Access Compliance Report

(Curb Ramps)

Intersection ID: 10735	Main Street: N_DAVIDSON_ST	Cross Street: E_27TH_ST	Location: SE
ADA ID: 3A2F16242968	Ramp Type: Perp	Initial Pass/Fail: Fail	Overall Compliance: No
Severity Score: 10			
Codes/Mitigation Info/Possible Solution		Field Measurements/Component Compliance

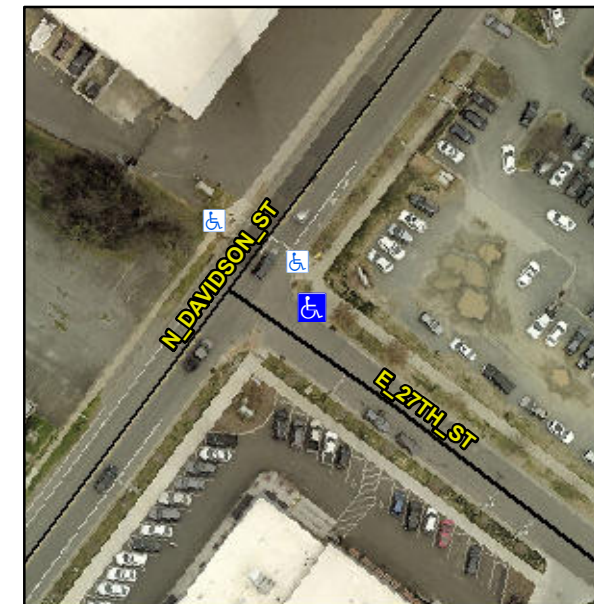
Not Found, R304.5.1, R304.5.3

Compliance	Description	Data	Compliance	Description	Data
N/A	Ramp Length (in)	99.0	Yes	Ramp Slope (%)	5.0
No	Ramp Width (in)	47.5	No	Ramp XSlope (%)	3.5
N/A	Flare Type LT	N/A	N/A	Flare Type RT	N/A
N/A	Flare Slope LT (%)	N/A	N/A	Flare Slope RT (%)	N/A
N/A	Flare Traversable LT?	N/A	N/A	Flare Traversable RT?	N/A
N/A	Landing Length (in)	N/A	N/A	DWS Provided?	N/A
N/A	Landing Width (in)	N/A	N/A	DWS Contrast?	N/A
N/A	Landing Slope (%)	N/A	N/A	DWS Length (in)	N/A
N/A	Landing X Slope (%)	N/A	N/A	DWS Full Width?	N/A
N/A	Landing Curb? (Y/N)	N/A	N/A	DWS Offset (in)	N/A
N/A	Shared Landing?	N/A			
N/A	Gutter Ponding?	N/A	N/A	Gutter Slope (%)	N/A
N/A	Gutter Lip Ht (in)	N/A	N/A	Gutter X Slope (%)	N/A
N/A	Painted X Walk1?	No	N/A	Painted X Walk2?	N/A
	X Walk 1 Direction	To SW		X Walk 2 Direction	N/A
N/A	X Walk 1 Width (in)	N/A	N/A	X Walk 2 Width (in)	N/A
	X Walk 1 Slope (%)	1.5		X Walk 2 Slope (%)	N/A
	X Walk 1 X Slope (%)	2.7		X Walk 2 X Slope (%)	N/A

Remove & Replace Entire Ramp.
